PRECAST INDUSTRY MEETING

ACPA Suggested Revisions

Jason Thorenson, PE
North Dakota State Bridge Engineer
Wed, October 29, 2025

REVISIONS TO 714-1: REINFORCED CONCRETE PIPE CULVERTS AND END SECTIONS

Concrete Pipe Plug Detail

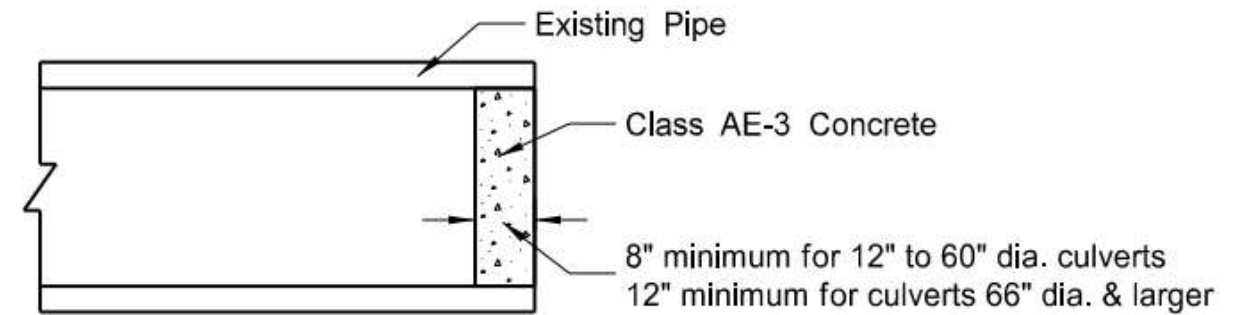
- Is there an option to use a precast plug/cap that would fit into the joint of the last section?
- NDDOT Response: Discuss with fabricators.

Bell and Spigot Joint Detail

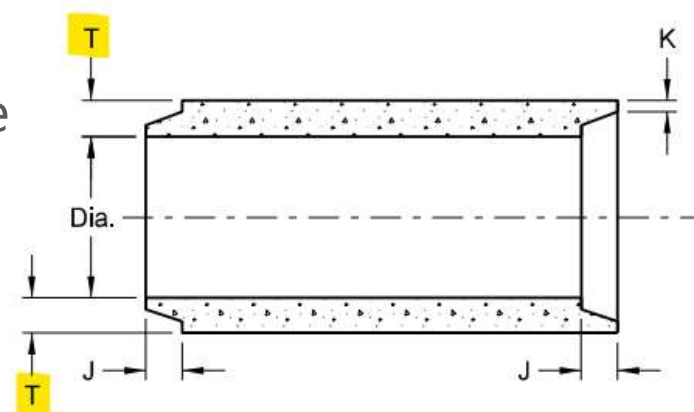
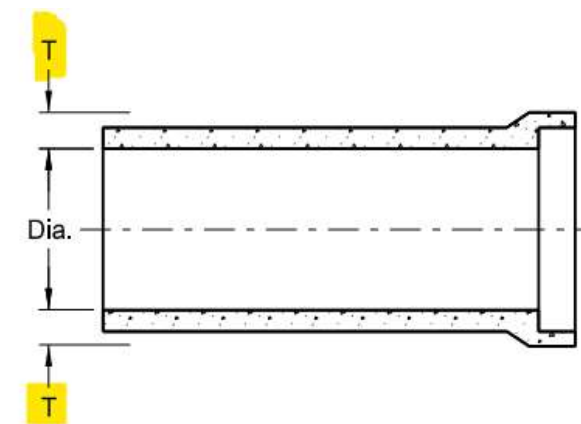
- T dimension should still be depicting the thickness of the wall. Recommend adding in a separate dimension for the distance that the bell protrudes past the barrel.
- NDDOT Response: We will revise.

Standard Drawing 714-25, 25M, 27, 27M, 28, 28M

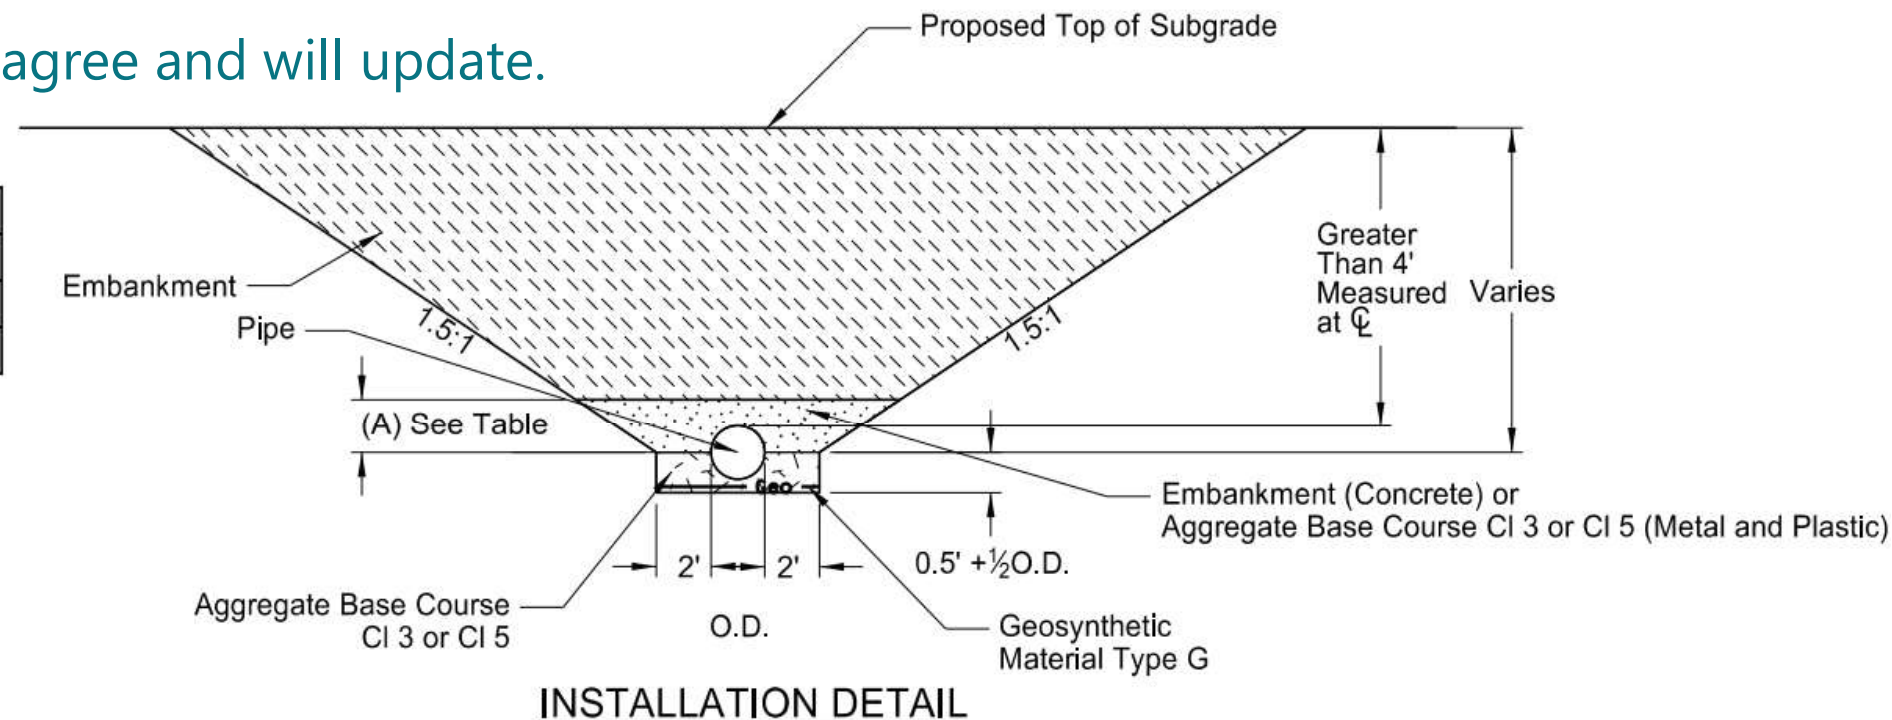
- **Backfill Dimensions (Table):** 'A' dimension should be 0, not $0.5 \times \text{OD}$ to match national standards and surrounding states. Structurally this does not need to be up to top of pipe. Concrete pipe only benefits from the soil beneath the springline or mid-height of the pipe cross section. See ASTM C1479, (Fig 2) and AASHTO Section 27 (Fig 27.5.2.2.1) for reference.
- **NDDOT Response:** We agree and will update.

Standard Drawings 714-25, 25M, 27, 27M, 28, 28M

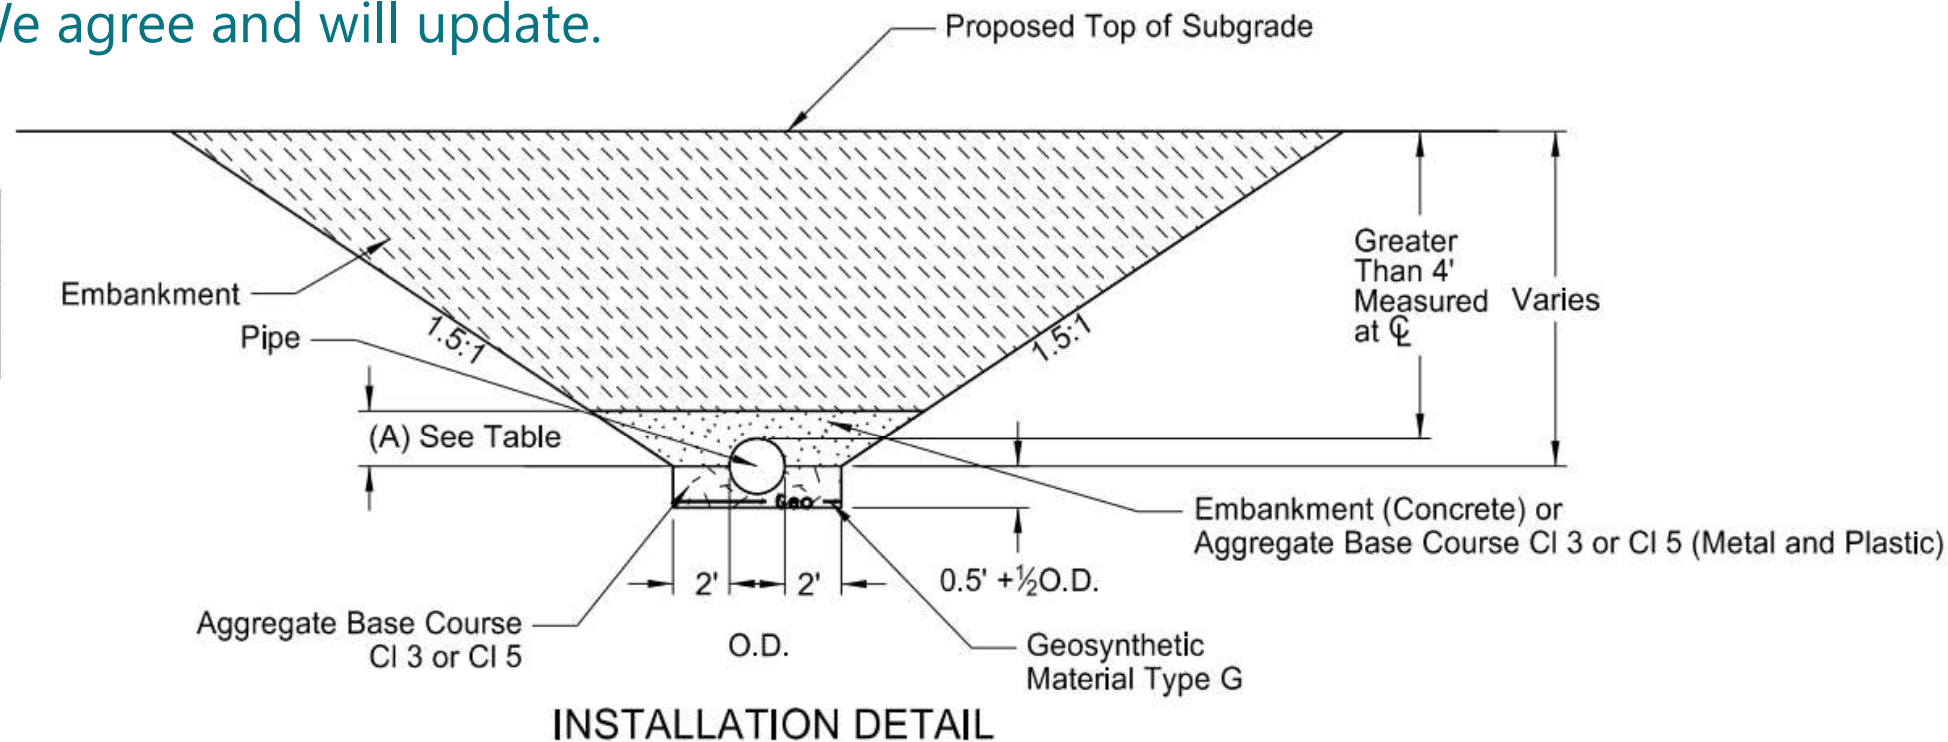
- **Installation Detail:** Would make more sense to include a dimension for the transitional material (from mid point to 1' above top of pipe) and then keep the note to use embankment material for concrete and Aggregate Base Course Class 3/5 for plastic and metal.
- **NDDOT Response:** We agree and will update.

Standard Drawings 722-1, 1A, 1B, 2, 3, 3A, & 5

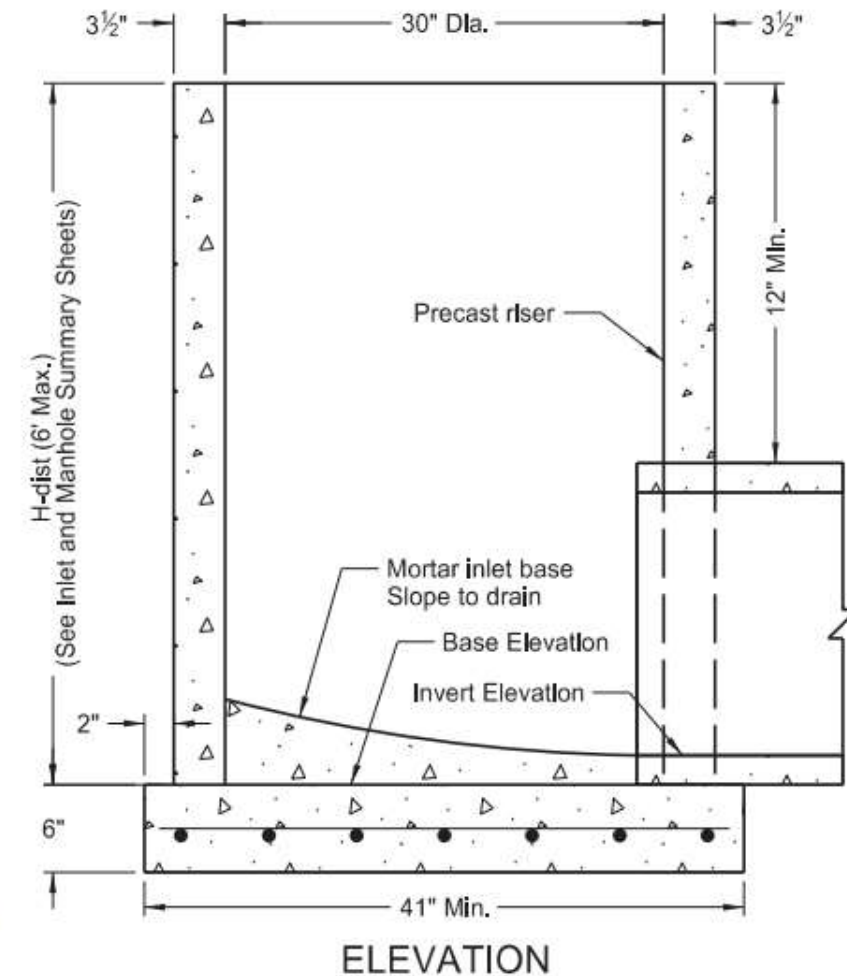
- **Manhole/Inlet Detail (Elevation View):** Add note "Use mortar to connect concrete pipes to concrete structures. Use flexible connections conforming to ASTM C923, when connecting flexible (plastic or metal) pipes to concrete structures." Flexible pipes do not bond well to concrete and have other issues related to deflection and thermal expansion/contraction that can cause issues at the connection point."
- **NDDOT Response:** Plan to update 722.04C and Standard Specification 714.04 A.9.

Standard Drawing **722-1B**

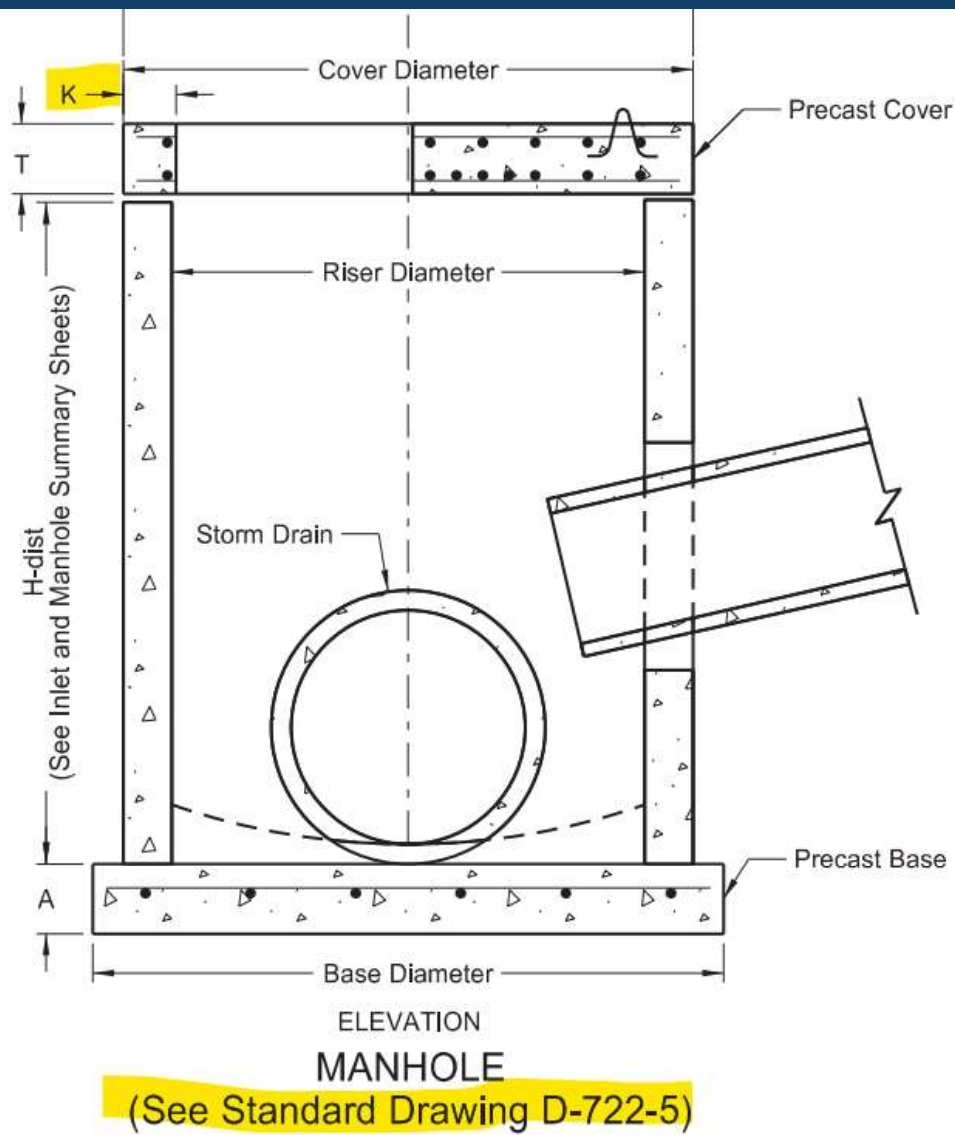
- **Manhole/Inlet Detail (Elevation View):** K dimension should be defined somewhere (typically manhole wall thickness + 1")
- **NDDOT Response:** This dimension is defined on D-722-5 which is referenced below the detail. However, it would make sense to have on this standard as well. There's plenty of room.

Standard Trench/Embankment Installation

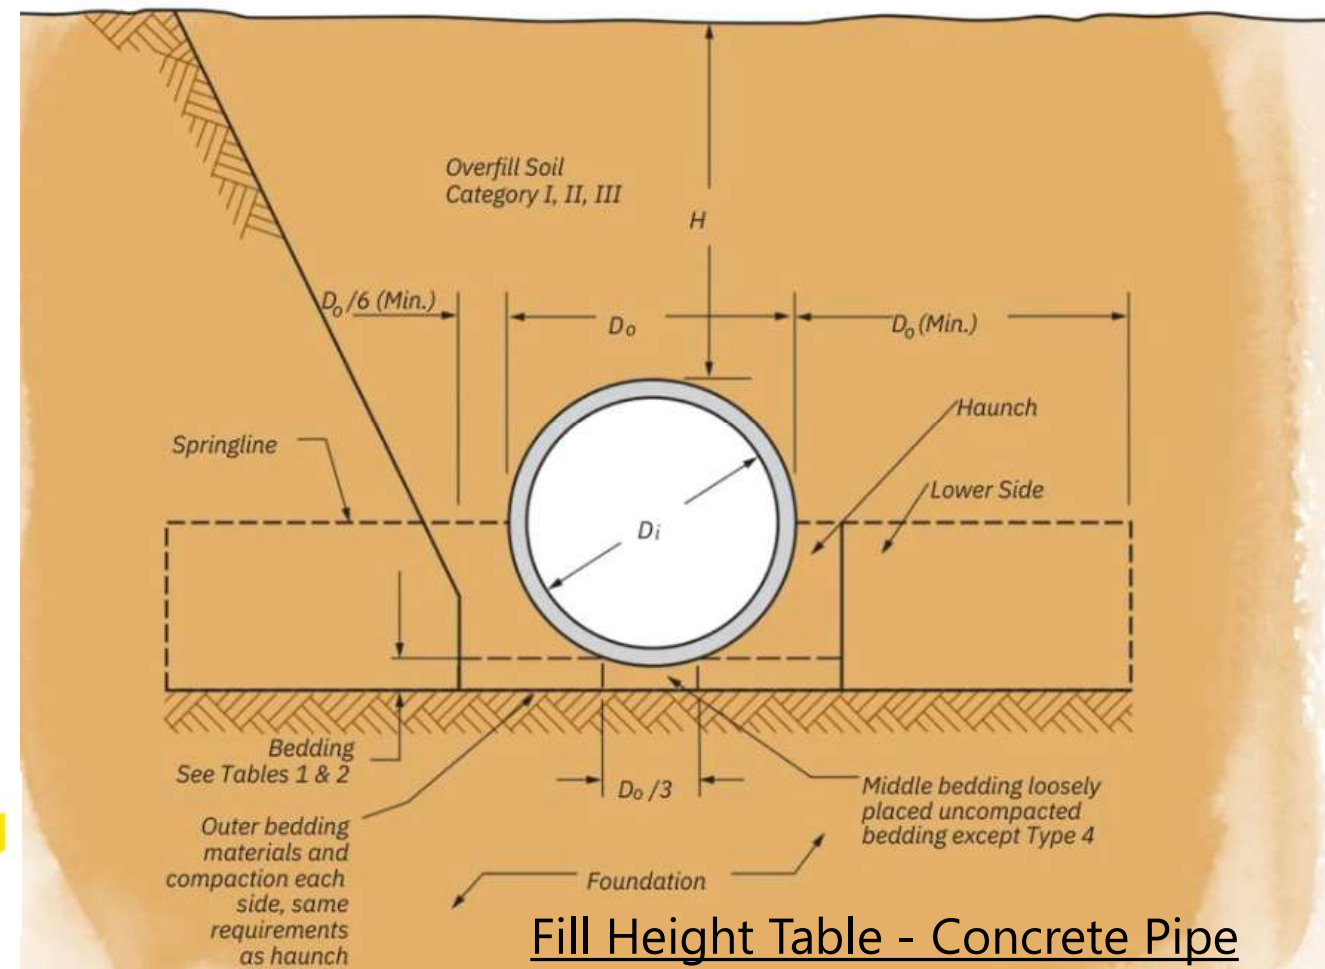
- **714.04-A.5:** Recommend removing reference to shaped bedding and replace with, "Bedding in the middle 1/3 of pipe O.D. shall be loosely placed." Use requirements of AASHTO sections 27 and 30 of the AASHTO LRFD Bridge Construction Specifications as a reference.
 - Section 27 (RCP) – Minimum 3" bedding with middle 1/3 uncompacted. 6" required with rocky foundation.
 - Section 30 (Thermoplastic) – Minimum not specified, maximum bedding thickness of 6" with the middle third uncompacted.
- **NDDOT Response:** Plan to review/revise as appropriate
